37/3-02EE 15 Montgomery Ave.
(Takoma Park Historic District)

SUBJECT: Historic Area Work Permit

HISTORIC PRESERVATION COMMISSION STAFF REPORT

Address:	15 Montgomery Avenue	Meeting Date:	08/14/02
Applicant:	Connie Meyer	Report Date:	08/7/02
Resource:	Takoma Park Historic District	Public Notice:	07/31/02
Review:	HAWP	Tax Credit:	Partial
Case Number:	37/3-02EE	Staff:	Robin D. Ziek
PROPOSAL:	Renovate and restore the house, including restoration of original siding, original window trim, and compatible alterations to front porch, and doors.		
RECOMMEND:	Approve with Conditions

Porch plans for Meyer, 15 Montgomery Avenue, Takoma Park, MD 20912

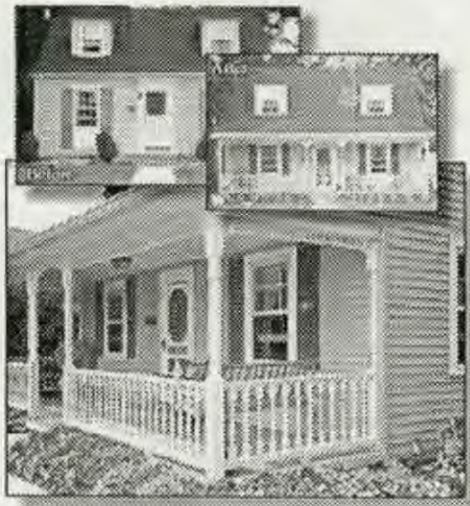
Here is a picture of our current front porch and front door. You can see the wood strip that is a different color, showing change in roof level. We plan to restore roof to what we believe was the original roof line.

Current porch structure in bad shape. Plan to tear down existing porch and rebuild to same style with above trim.

Roofing material for Meyer residence, 15 Montgomery Avenue, Takoma Park, 20912

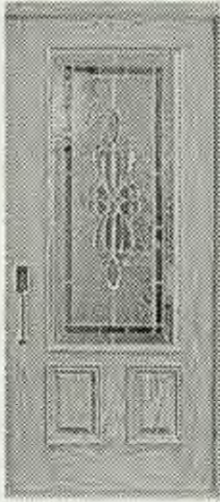
The proposed use of the slate substitute material is in-keeping with the overall intentions to restore the property to its original historic character. Slate would have been an available roofing material at the time of construction, and there are several homes in the Takoma Park Historic District with slate roofs. Staff concerns include consideration of the weight of the new material in terms of the structural capacity of the roof rafters. This must be adequately considered by the applicant and the contractor. Staff notes that research printed in the July/August 2002 edition of *Old-House Journal* indicates that the rubber slate product weighs less than the asphalt shingle Grand Manor Shingle (see Circle 22). As there is no documentation about the original roofing material, the applicant could choose amongst the

New front door for Meyer residence, 15 Montgomery Ave.,
Takoma Park, MD 20912

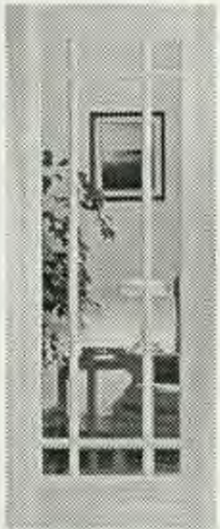
Mahogany door with beveled glass. Matching transom.

Matching the width and height of existing door and transom.

The proposed new front door is clearly a modern rendition designed to evoke the ornate Victorian era. It will be clearly understood as a new door, and staff feels there is leeway here for the applicant's preference because they are not replacing the original door.

Outline of window decorative trim.

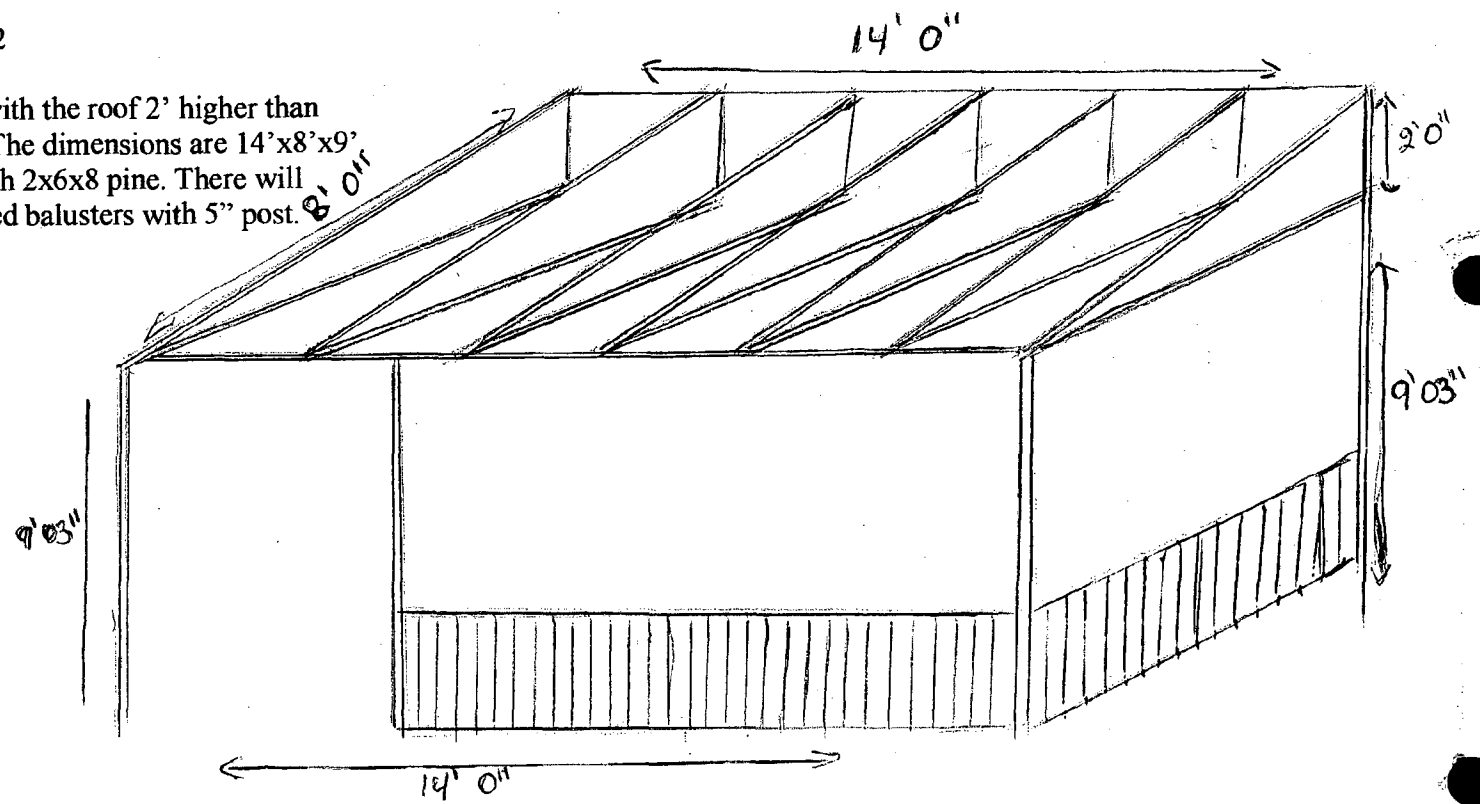
Design for new trim piece. We will put these over every window in the house (old part and the addition added in 1986) to tie the look of the house together.

The applicant is to be applauded for the restoration intentions of this project. For that reason, the staff recommends that the applicant follow exact details when they are extant, while also recommending that there is more leeway when such historic details are not known. With this guideline, staff notes that the molding used on the sample window to the left of the porch is too decorative, and not in-keeping with the simple lines of this vernacular Victorian. The authentic weather mold is a single rounded shape, which protrudes slightly out above the triangular window head. This detail should be copied for the rest of the windows, rather than using tacked-on decorative molding.

1. Replicate the original trim detail for the windows, by matching the trim detail from the front door.
2. Work with staff to provide drawings of proposed new porch roof form for the record, recording the roof relationship to columns, front door, and window head.

Porch plans for Meyer, 15 Montgomery Avenue, Takoma Park, MD 20912

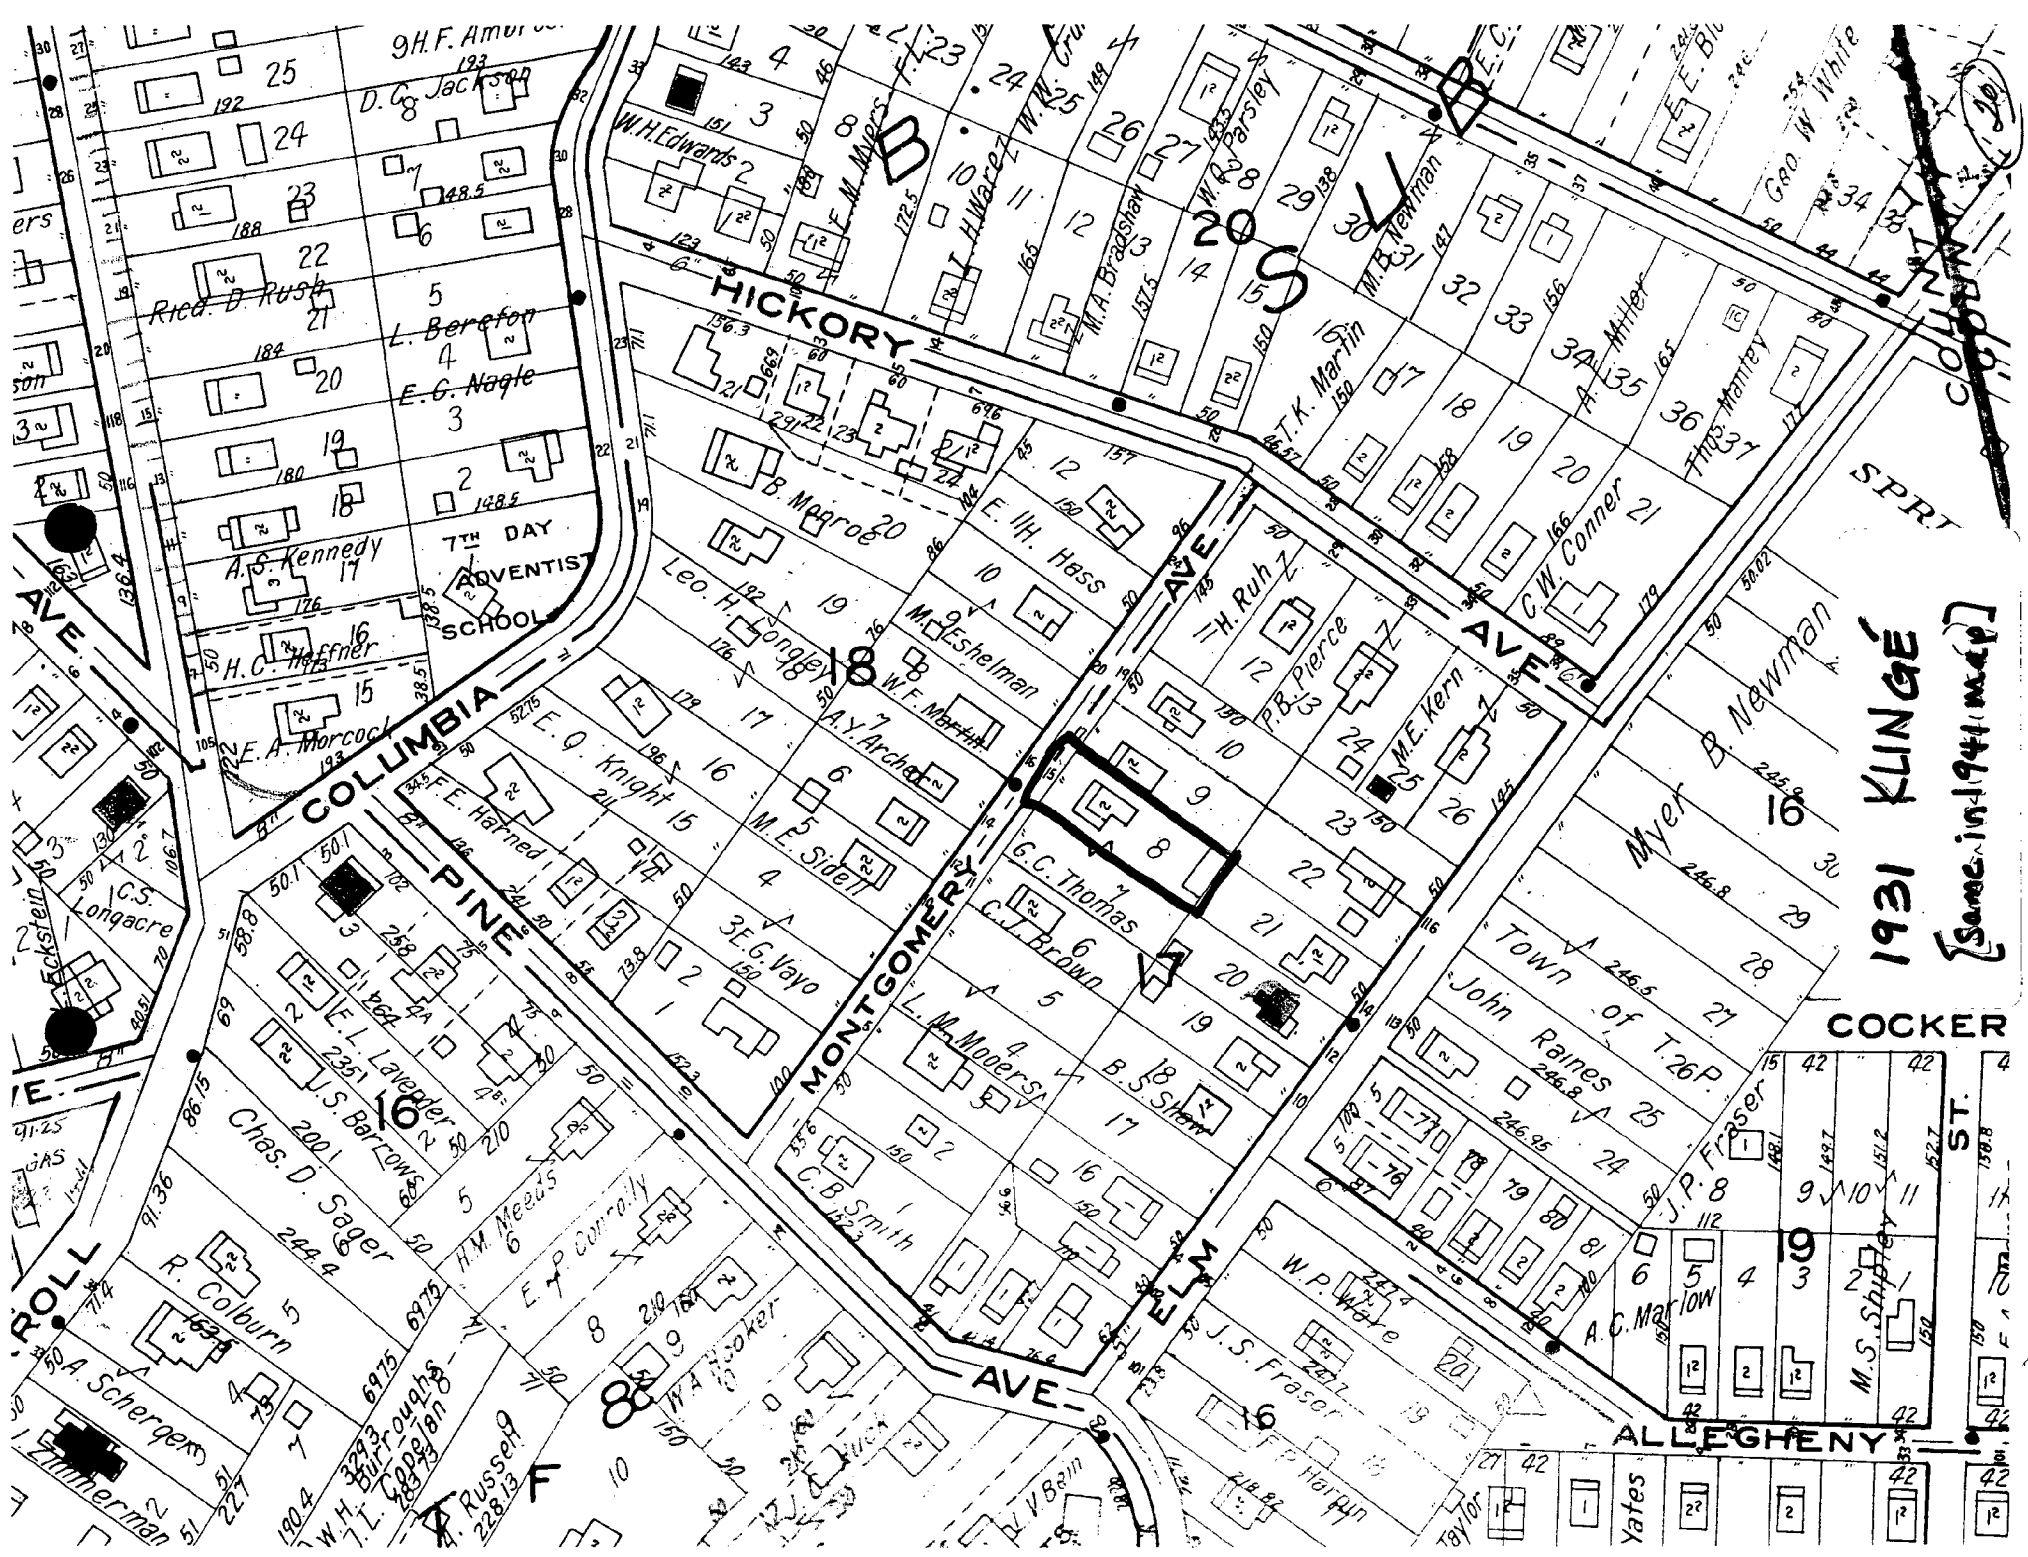
With regards to the porch, staff notes that a modifications proposed are to an already modified porch. According to the 1931 Klinge insurance map, the house had a wrap-around porch originally. This can also be inferred from the siding. The proposal is actually a modest alteration to the existing small porch, and works within the vocabulary of the Victorian vernacular structure. Staff feels that it may be somewhat more decorative than was likely, but this is also conjecture. Given that, staff supports the applicant's proposal.

We need to take down this porch -
Roof area very damaged -
we plan to rebuild it - some
space + design - 2ft. higher
where we believe it
was built on the original
house.
